STAFF REPORT: SEPTEMBER 11, 2024 MEETING (*Revised 9/10*)

APPLICATION NUMBER: HDC2024-00495

ADDRESS: 3747 TYLER

SCOPE: INSTALL WOOD WINDOWS, DOORS AND ERECT REAR PORCH

Applicant drawing, revised 09/10/24.

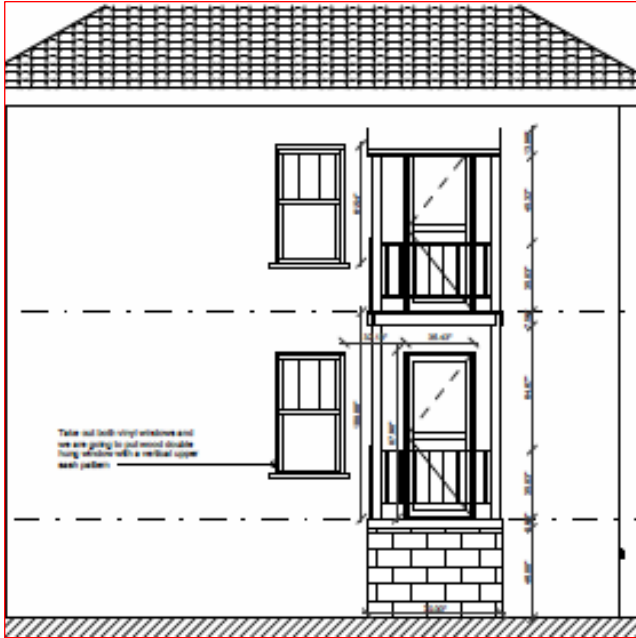
- ~~The current application reverts to matching the historic window operation of each opening on this wall. However, the historic muntin pattern was a linear 3 over 1, not 4, 6 and 9 over 1.~~
- This dwelling is a two-family flat, and the application includes the installation of a new doors within each existing door opening. The six-panel offers a minimal design with vertical proportion, and it is staff's opinion they are compatible for this property, however the selected color of white is not compatible with the architectural design of the dwelling.

- For the replacement windows at the side and rear walls, solid wood or aluminum-clad wood windows will be selected. Cut sheets confirming the manufacturer, product line, material, operation, color, and simulated divided light dimension and profile will be submitted for staff review. All double-hung windows will have a 3-over-1 pattern, and the small square windows will not have any glass pattern. A window schedule that confirms the details for each window will be submitted for staff review.

- The six-panel doors proposed for the side and rear elevations will be dark brown. A cut sheet confirming the design, color and material will be submitted for staff review.

Applicant drawing, revised 9/10/24

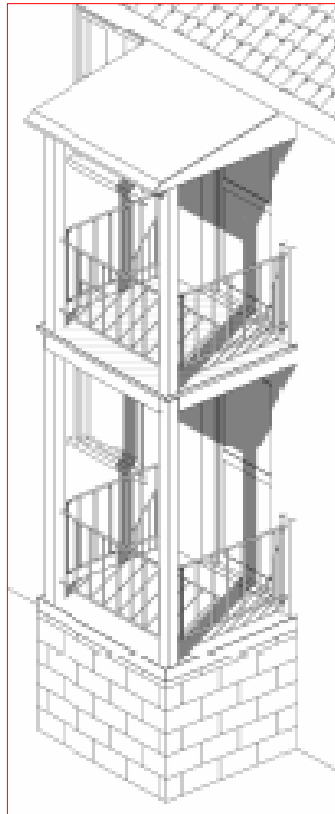
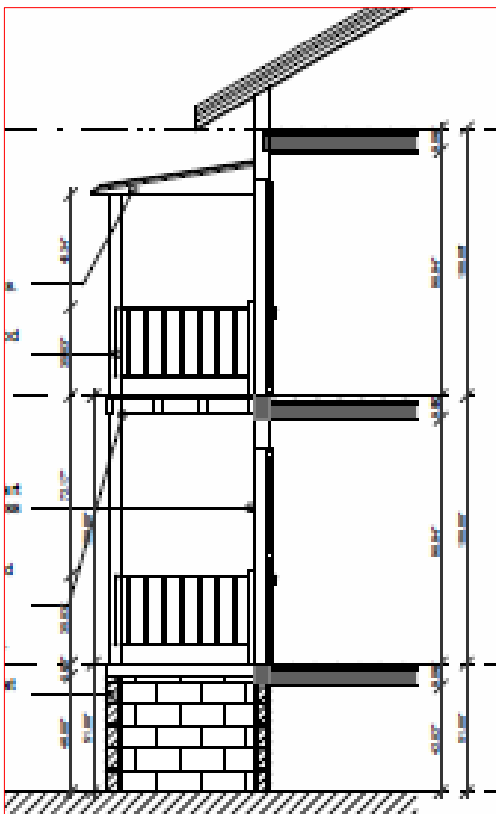
- The application proposes to remove the vinyl windows and install wood windows with a 3-over-1 pattern to match the documented historic condition. A two-story porch is proposed in a dimension and design that is similar to the ghost images shown in the 2018 photo that documents the placement of the former porch.

- It is staff's opinion that the historic porch was likely wood construction (based on the width of the railing profiles) and that wood construction for the new *footings*, posts, railings and landings (no concrete block or iron railings/posts) would be compatible at this rear, secondary location. An awning for the upper porch, as drawn, is also a compatible design option at this location.

- The aluminum coil stock that was installed to cover the window opening's wood brickmould will be removed.
- The two-story rear porch will specify wood components for the **footings**, posts, railings and decking. The perimeter railings will have a top and bottom rail and vertical spindles and will be tied into the porch's supporting posts; a freestanding, independent railing system as currently proposed will not be selected. The entire porch system will be painted three – six months after installation; paint color will be submitted to staff for review. If an awning is selected to cover the upper porch, a catalog cut of the product that includes the dimensions, method of installation, materials, fabric color and pattern will be submitted to staff for review. A revised dimensioned elevation drawing of the two-story porch that calls out materials and finishes will be submitted to staff for review.
